RESPONSE TO NOTICE OF LRD OPINION

BALLINACURRA MILL LRD (Ref. PPE22 605)

**128 Residential Units, 5 Commercial Units, café, creche & associated site works
at Rose Hill House & Ballinacurra Mill, Ballynacorra East, Midleton, Co.Cork**

Figure 7.1 – Works Phases 01 - 06

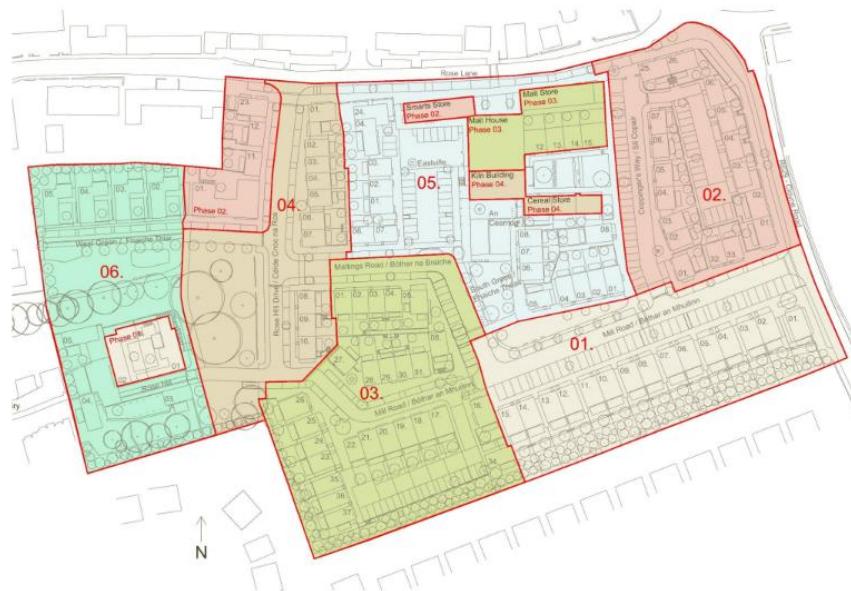
The lack of a detailed strategy illustrating the comprehensive and coherent delivery of all components of the development represents ad-hoc, piece-meal development, contrary to the proper planning and development of the area. The potential that the Protected Structures shall be siphoned off, set aside (or project splitting) to third parties with a likelihood of continued dereliction is unacceptable.

Any sub-division or setting aside of works to RPS structures with the 'town centre' zoned lands would constitute a failure to protect and reuse the protected Maltings (Industrial Buildings), would contravene the MD-T-07 Objective for the site, and similarly, the sub-division or failure to incorporate the redevelopment/ re-use of Rose Hill House would be inappropriate and unacceptable to the planning authority. In general, the

Please refer the Phasing Drawing prepared by Fourem Architects – entitled Phasing of the Works in page 29 of the Design Statement. It outlines 6 no. phases.

The phasing plan is designed to allow for the delivery of new housing in conjunction with works to Protected Structures and survey of industrial heritage (both in early phases). For clarity, works to Rose Hill House commence in Phase 1 and works to former Malting buildings commence in Phase 2, 3 and 4. The creche is included in Phase 2.

Proposed ground floor of Cereal Store

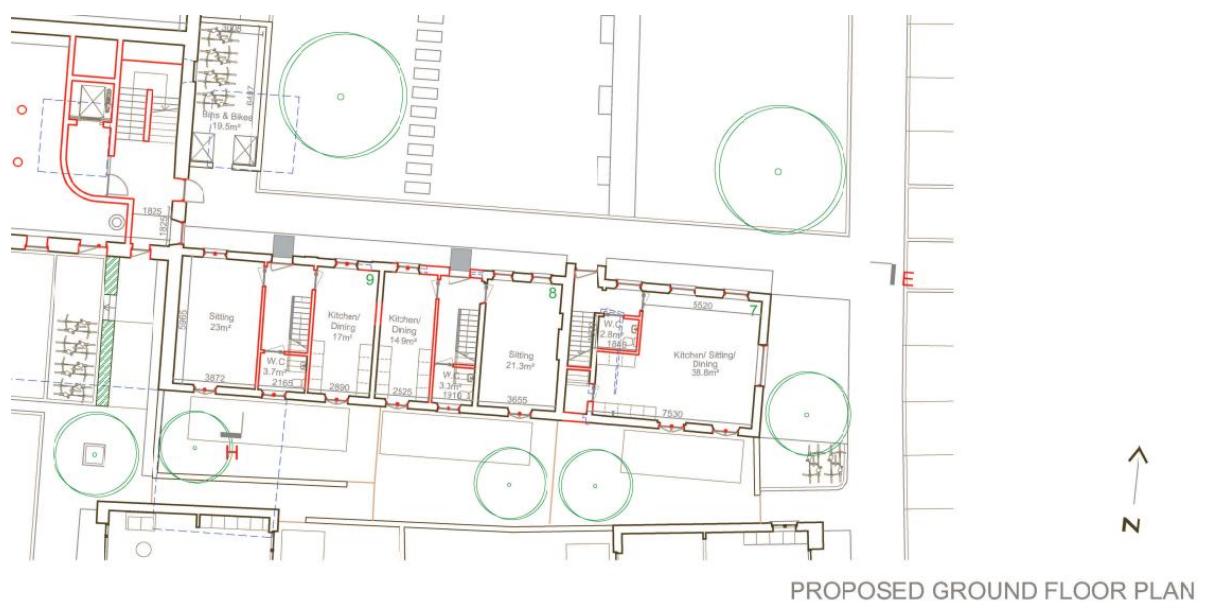
The demolition of the 'cereal lab' is unacceptable.

The proposed detailing of the rebuild of the upper floors of the maltings/kiln house side (flat zinc roof, zinc finished wall, as opposed to retaining the stone wall and existing opes detailing) is inappropriate and unacceptable. Detailing of proposed lifts and

The Cereal Lab is retained and will be converted into 3 no. dwellings.

The Malt Store was redesigned to be more in keeping with the historic character. The flat roof & zinc finished walls were removed. The Roof was revised to be a pitched roof more in keeping with the existing buildings. The materials of the façades were reconsidered to be more sympathetic with the historic setting. The elevations (particularly on the north) were redesigned to maintain more of the existing openings & character. Internal layouts have been reconsidered throughout. This addressed the councils concerns re services – for example larger spaces have been provided for bin & bike storage and the stairs layout has been adjusted in the smarts store.

Extract from site layout plan showing raised pedestrian crossing along internal road to the south of the site

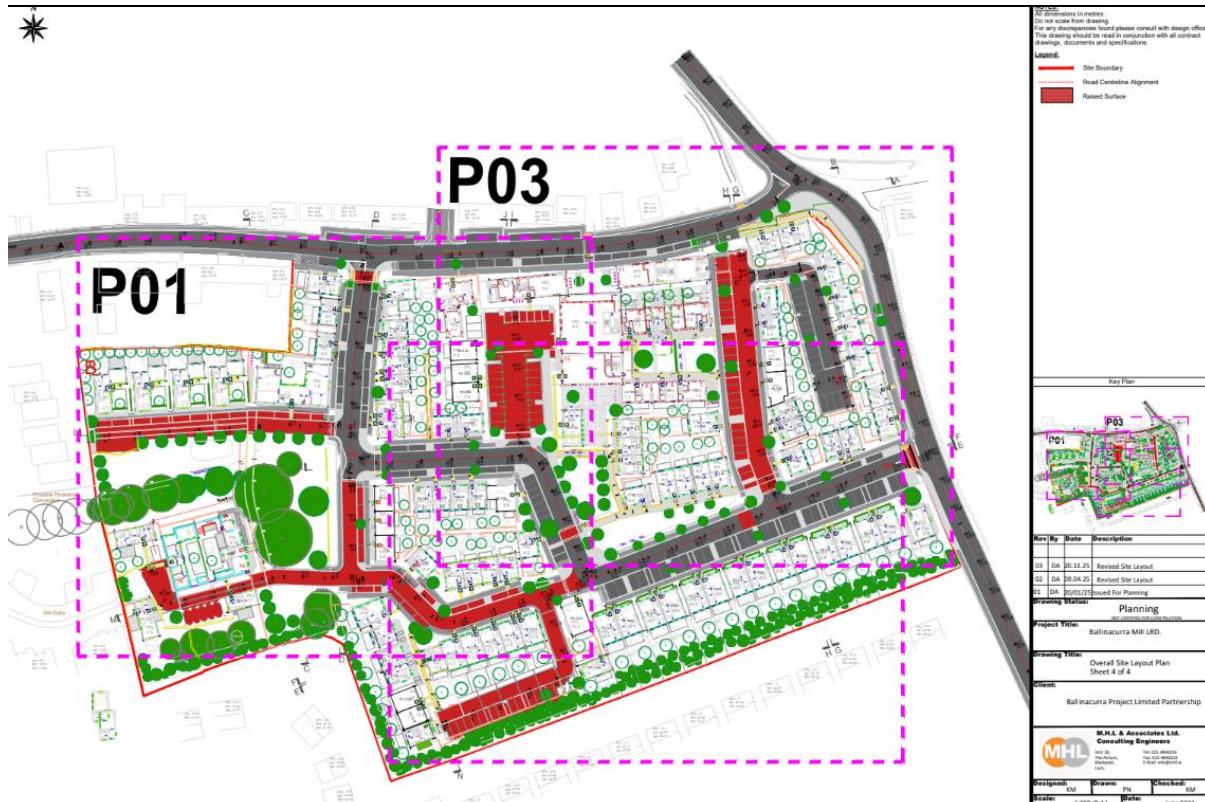
The proposed internal road exiting from the R629 (at the eastern end of site) may give rise to speed issues and should be re-designed/ re-aligned to include calming measures such as horizontal deflections, vertical deflections, visually narrowing the combined carriageway/ parking way with particular attention to the entrance of the home zone at western end of the 'straight' (road).

The internal road has been re-designed to include calming measures in the form of a raised pedestrian crossing to deter speeding. The 90 degree turn at the west end and pedestrian crossing at the east end will also serve to slow down traffic speed.

Extract from drawing No. 23072HD-PRW-PO1

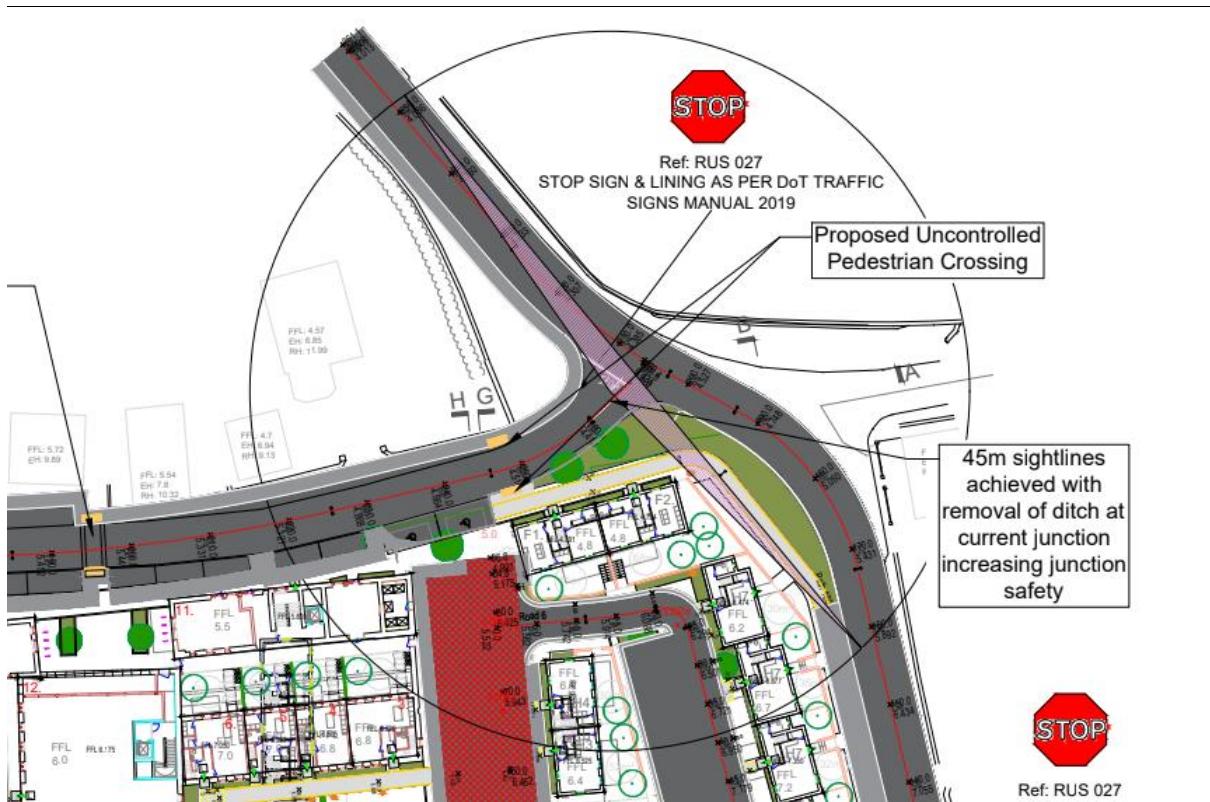
Further details of the junction improvement works at Kearney's Cross are required, where the R629 should be treated as a bus route.

Refer to layout of junction is as per drawings 23072HD-PRW-PO1, 23072HD-LS-PO1, 23072HD-LS-PO2. The applicant invites a condition of planning permission for detailed design of this junction will be agreed with Local Area Office prior to construction.

Taking in charge diagram.

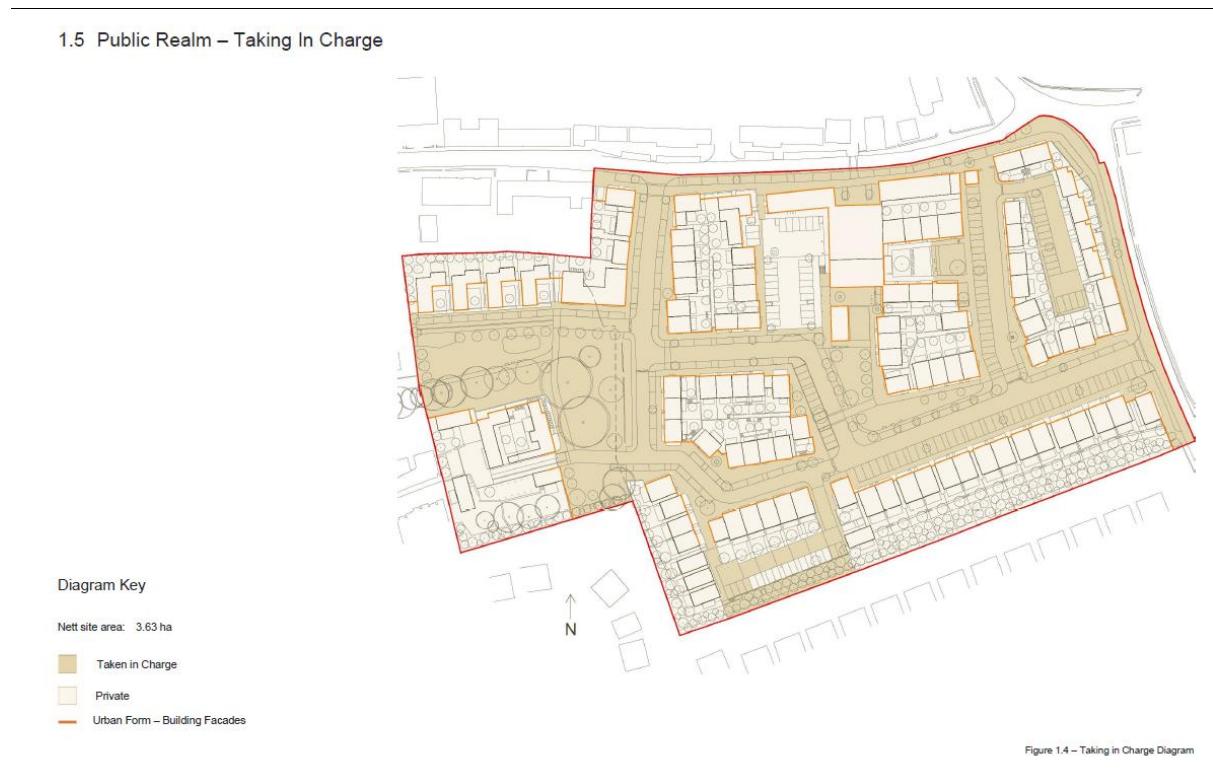
The submitted Taking-in-Charge plan is unacceptable and should be revised to exclude mixed-use/ apartment blocks and commercial units and associated services such as amenity spaces, car and bicycle parking, bin storage.

A management company or companies shall be formed to manage apartment and commercial blocks and their associated infrastructural services. Details of same is required, should have regard to the above stated opinion on Part V units.

Refer to the revised Taking in Charge diagram prepared by Fourem Architects in the Architectural Design Statement. It now excludes mixed-use/ apartment blocks and

commercial units and associated services such as amenity spaces, car and bicycle parking, bin storage.

A Management company will be formed to manage the apartment and commercial blocks as well as associated infrastructural services – refer to the Building Lifecycle Report prepared by Fourem Architects.
